CONSTRUCTION PLANS FOR CARRIAGE MEADOWS SOUTH AT LORSON RANCH

STREET, STORM SEWER, AND POND CONSTRUCTION PLANS

COVER SHEET
STREET, STORM SEWER AND POND
CONSTRUCTION PLANS

DATE: MARCH, 2017
 PROJECT NO. 100.030
 SHEET NUMBER C6.14
 TOTAL SHEETS: 37

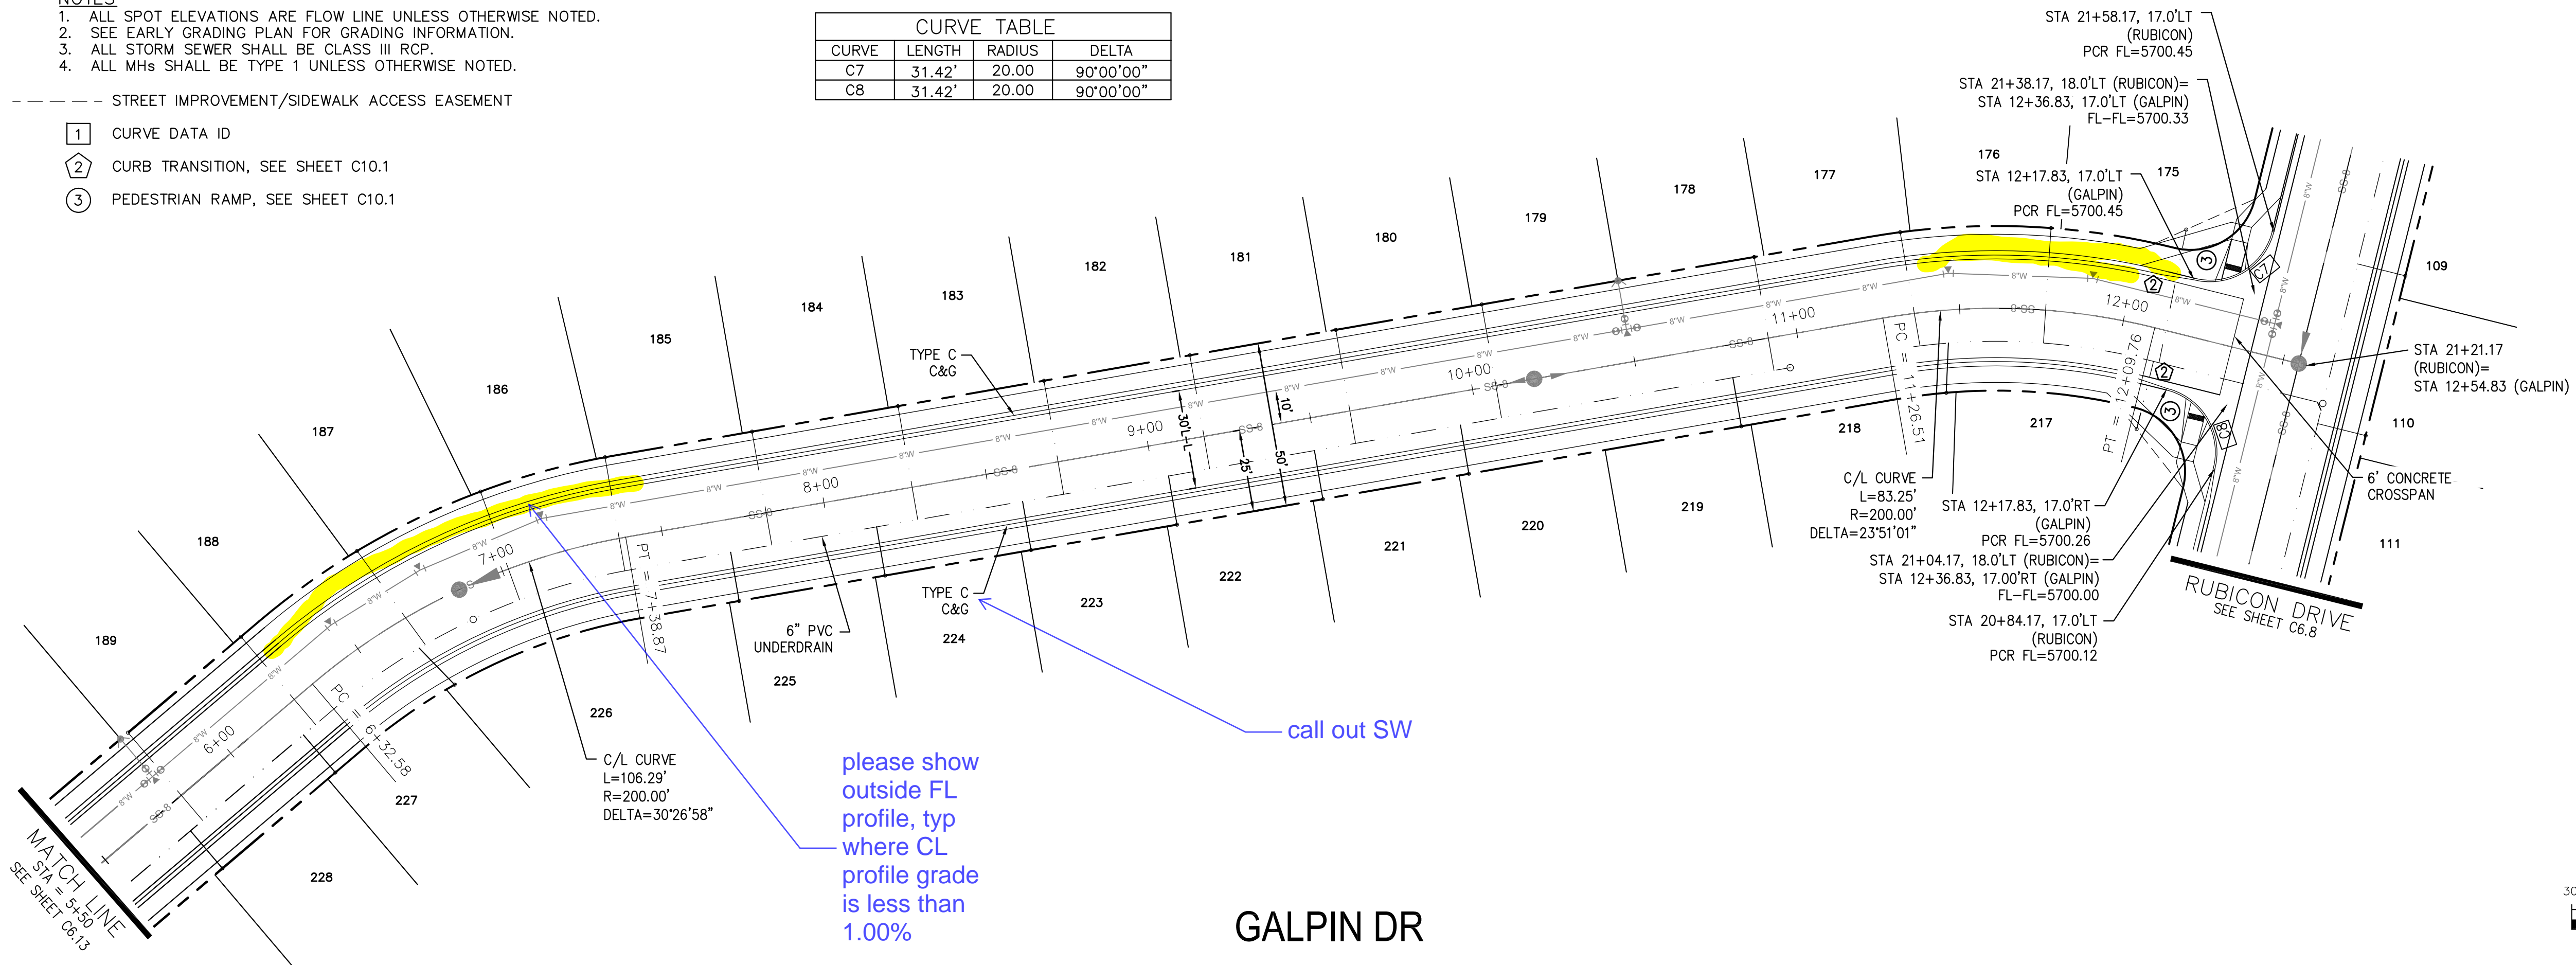
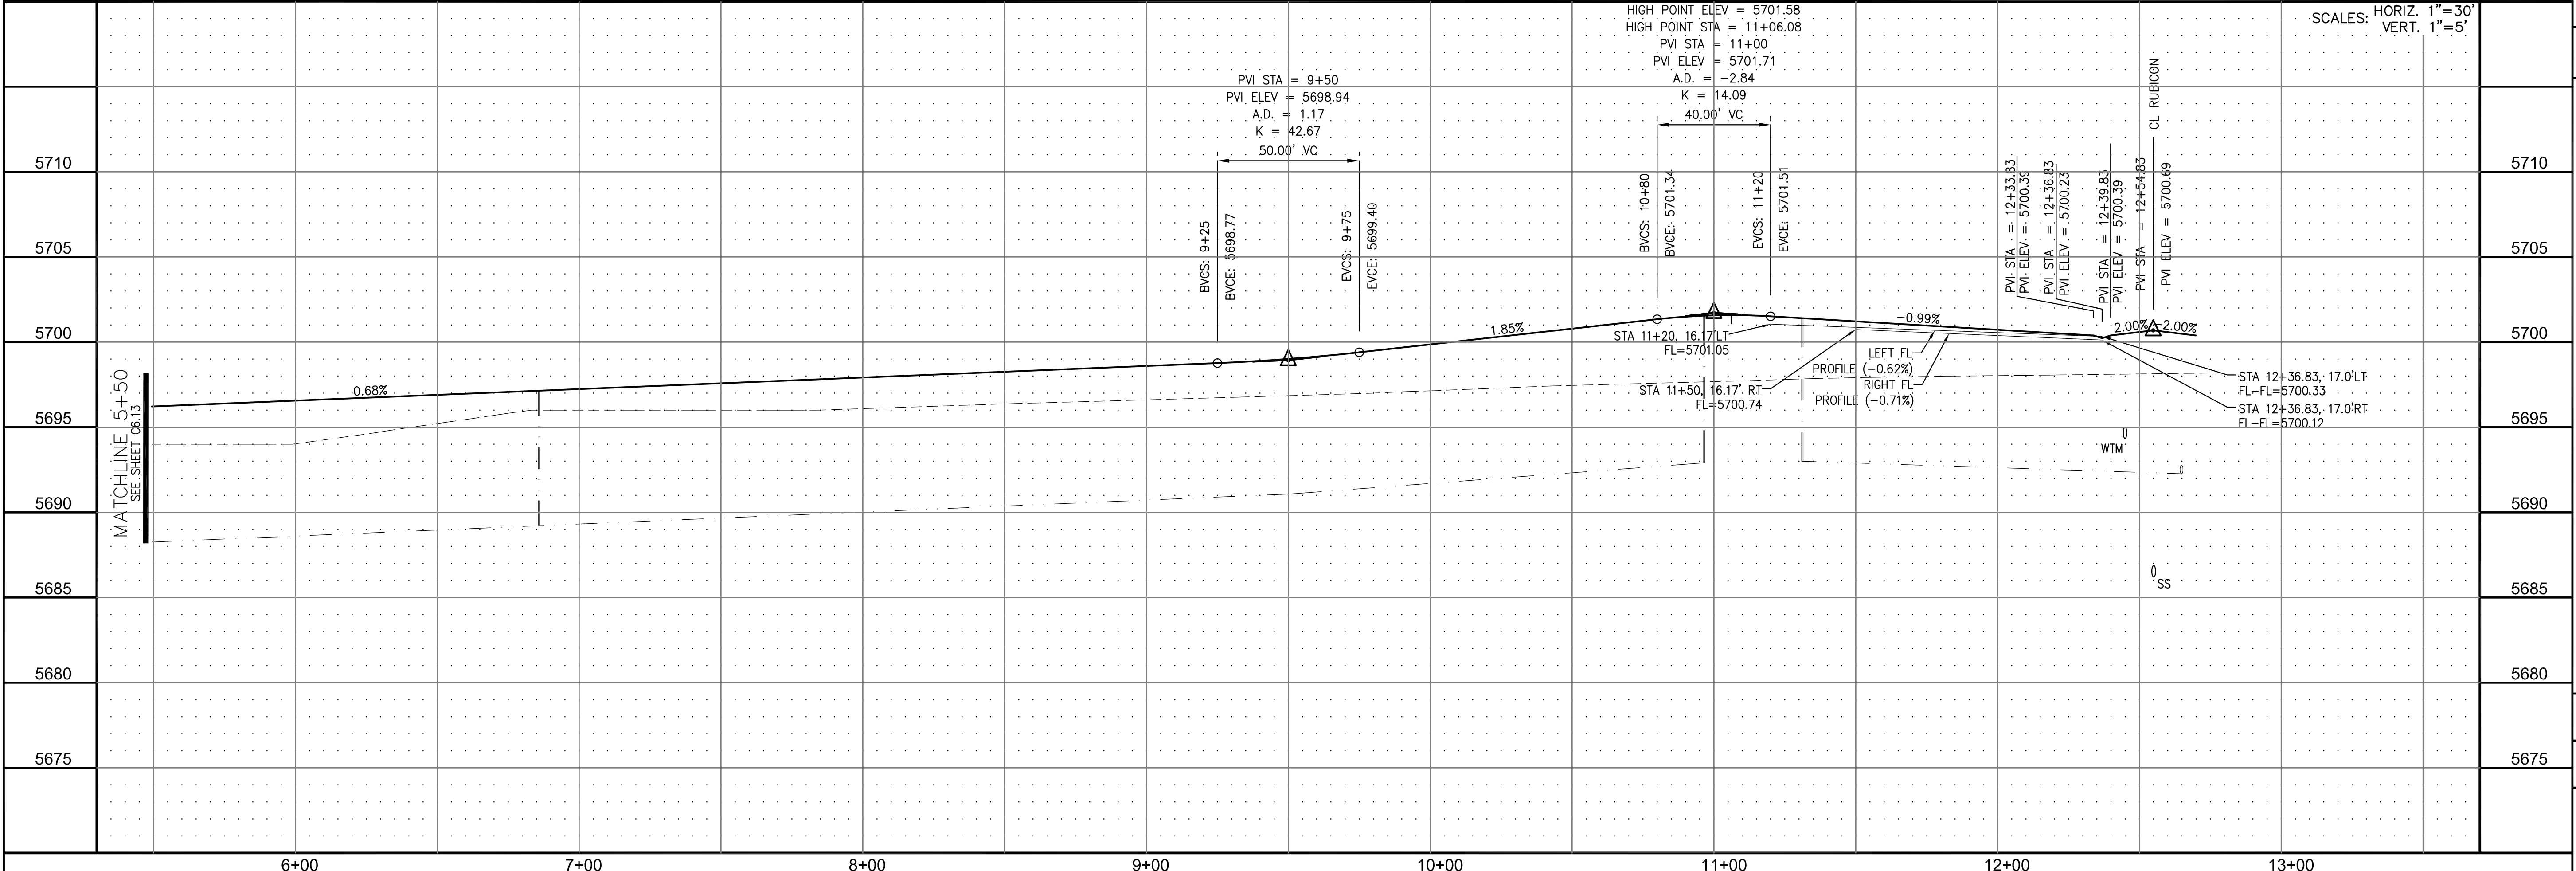
please show outside FL profile, typ where CL profile grade is less than 1.00%

SHEET NUMBER C6.15

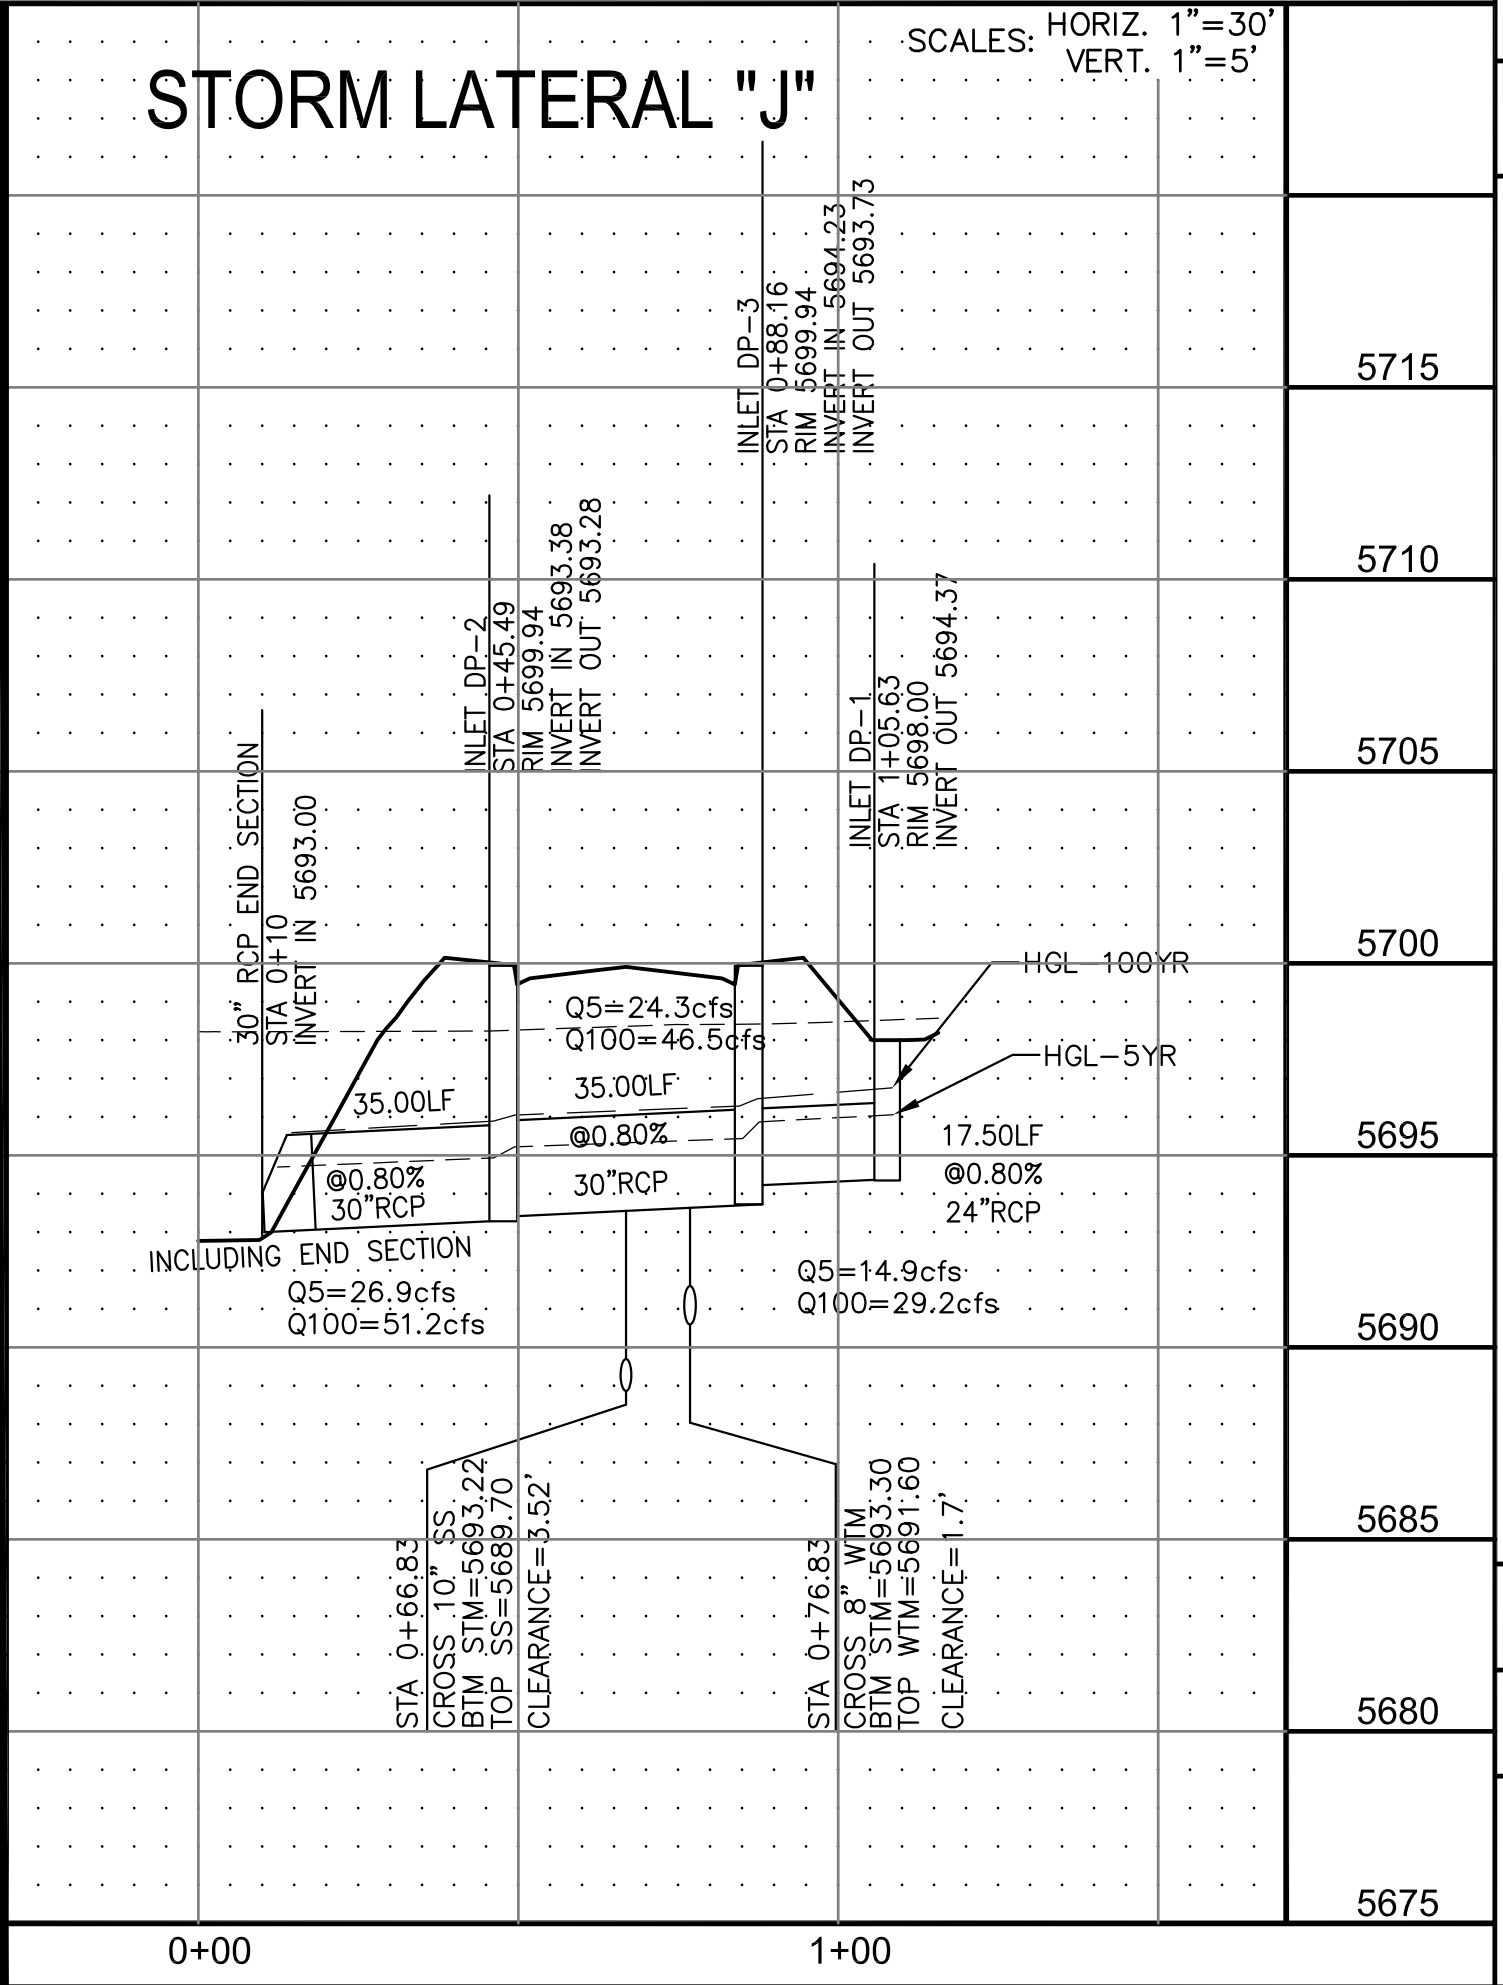
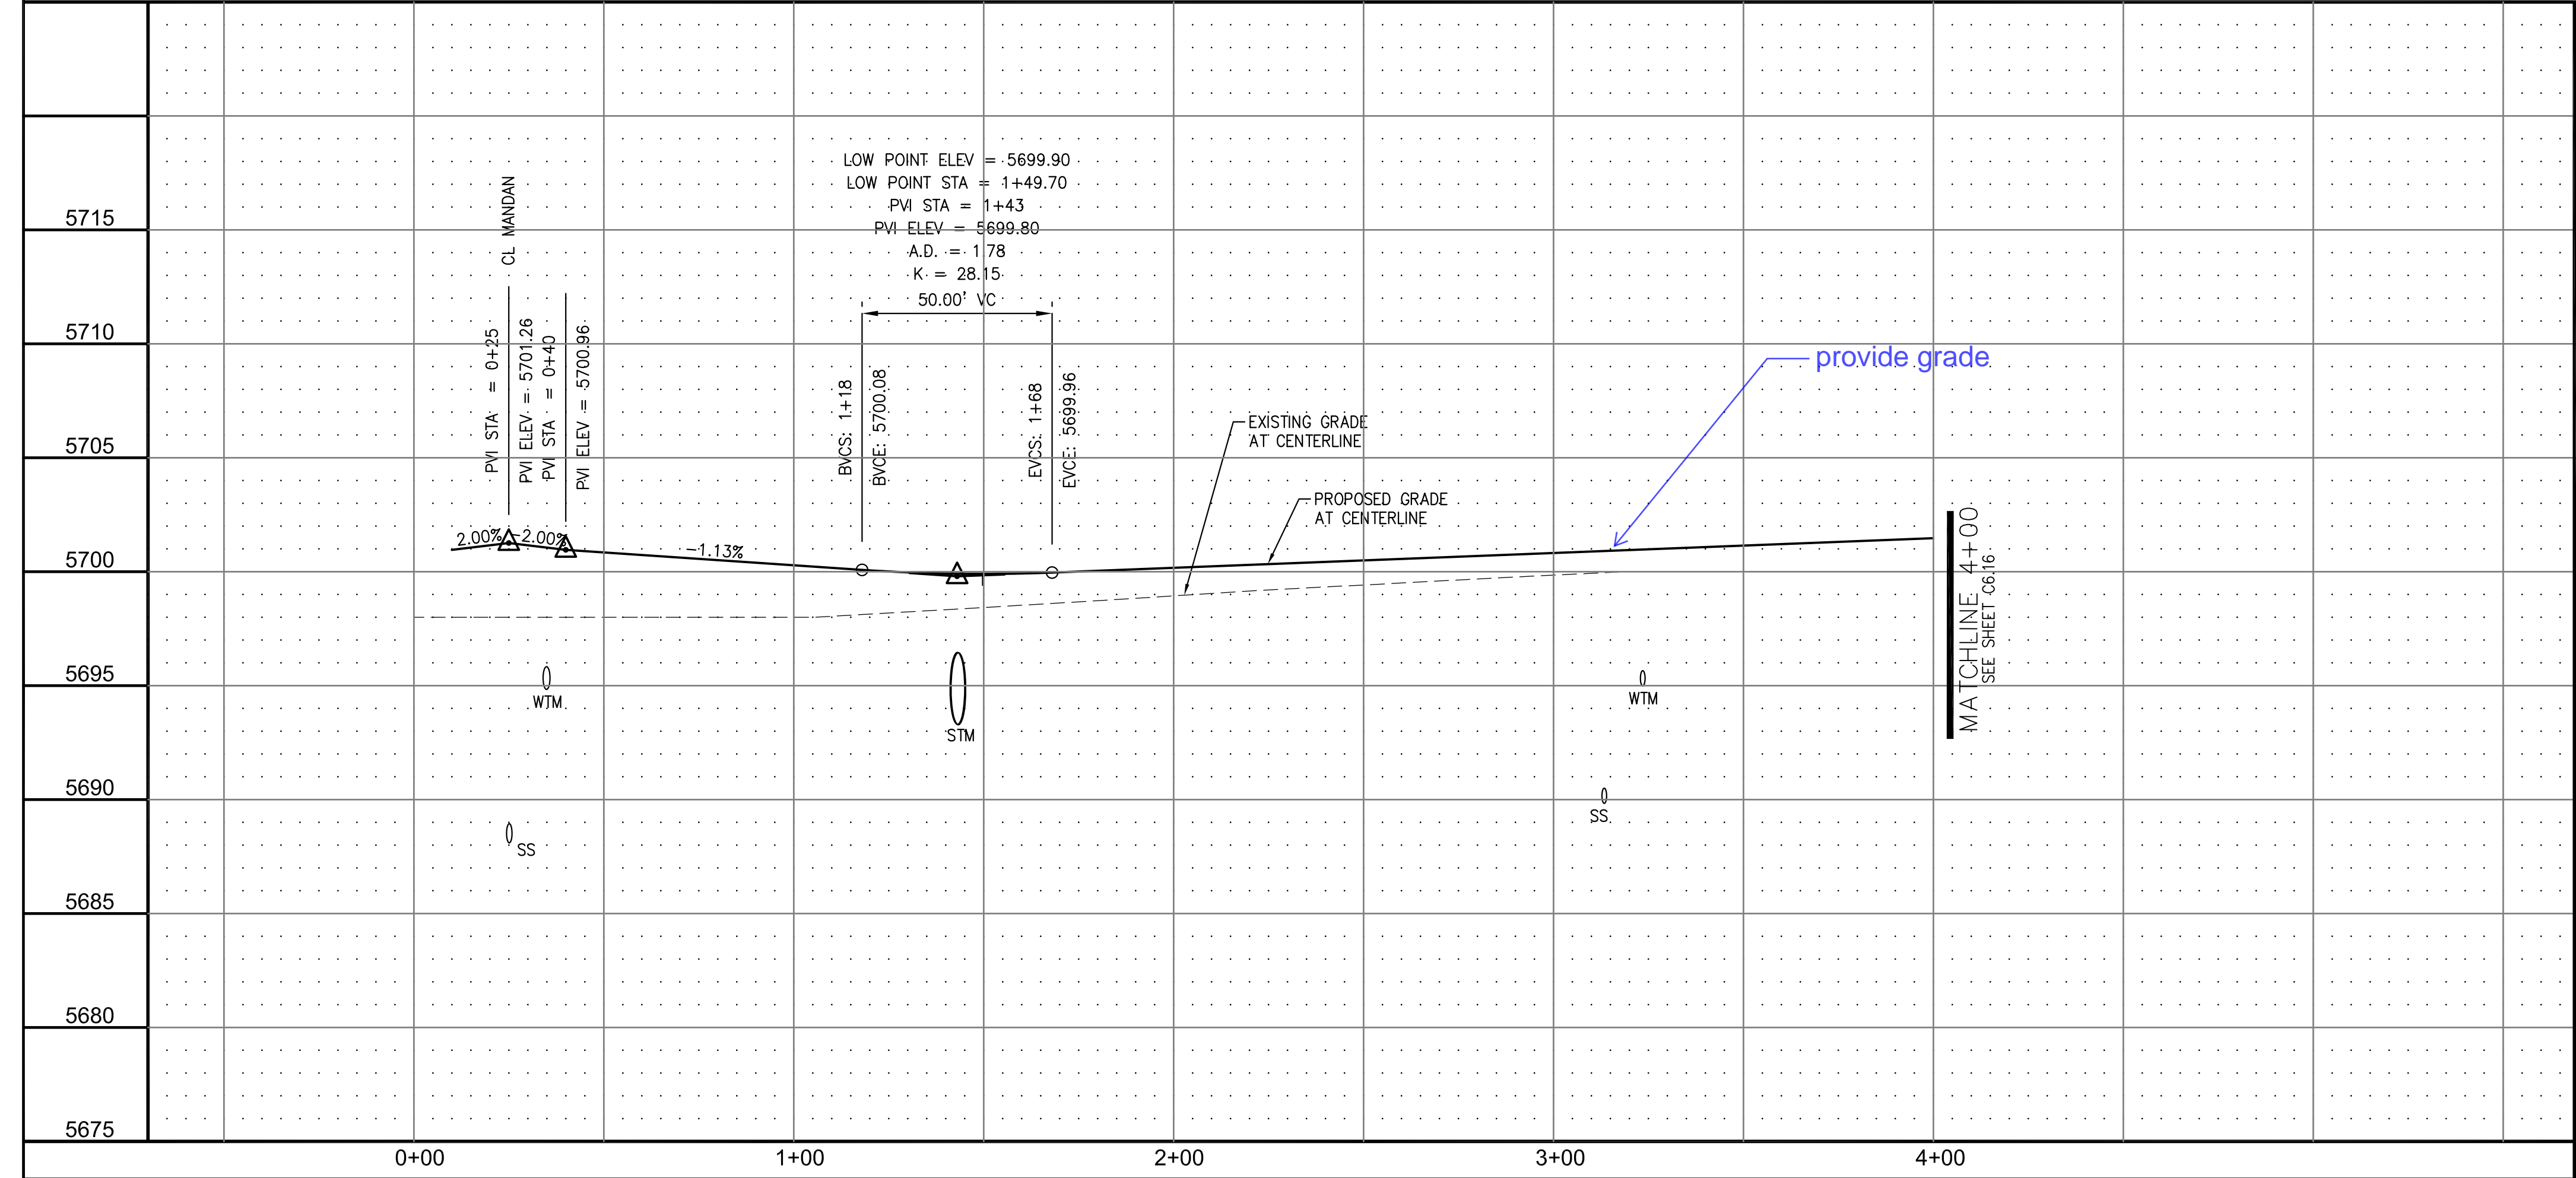
While the size of these inlets are labeled correctly, it appears as if the DP designation is reversed. Please clarify.

if CL grade is less than 1.00%, please provide FL profile.
